DOCUMENT CHANGE REQUEST

DCR number 169	Changes required for: General	Originator: S Thacker
Date: 2005/04/14	Date sent: 2005/04/14	Organisation: ESA/ESTEC
Status: IMPLEMENTED

Title:	Capacitors Fixed Ceramic Dielectric Type I High Voltage 1.0 to 5.0kV, based on case styles VR,CV &		
Number:	3001/033	Issue:	1

FIGURE 2(a) - VR STYLE

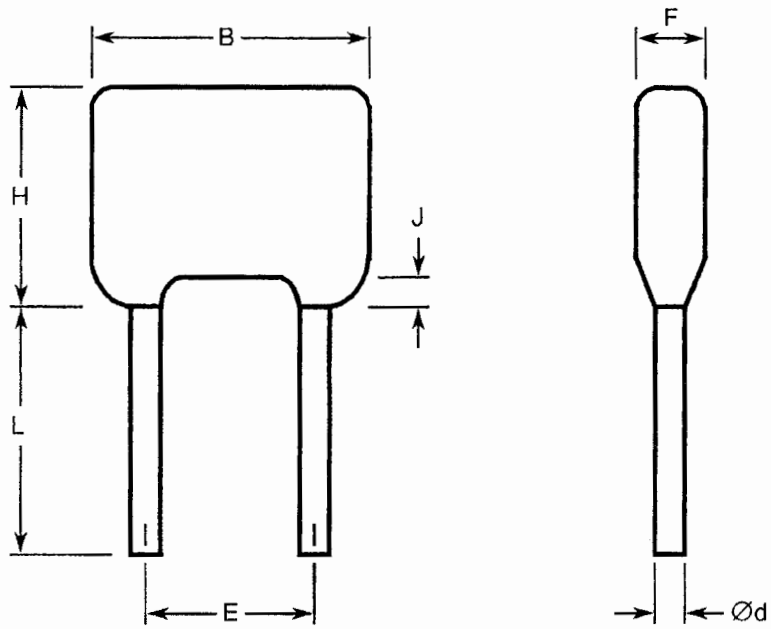
Figure 2(a) - VR style dimensions to be amended as follows:
Variant 01, 02, 03 dimension "Dia d" to be 0.46mm min; 0.56mm max (was 0.51/0.61)

Variant 02 dimension "H" to be 9.62mm max (was 7.62)

Variant 06 dimension "H" to be 19.78mm max (was 17.78)

Correction of typographic errors.
Specs are now consistent with ESCC 3001/030 & 3001/034 per DCR131 for similar types.

0.46 0.56 9.62

19.78
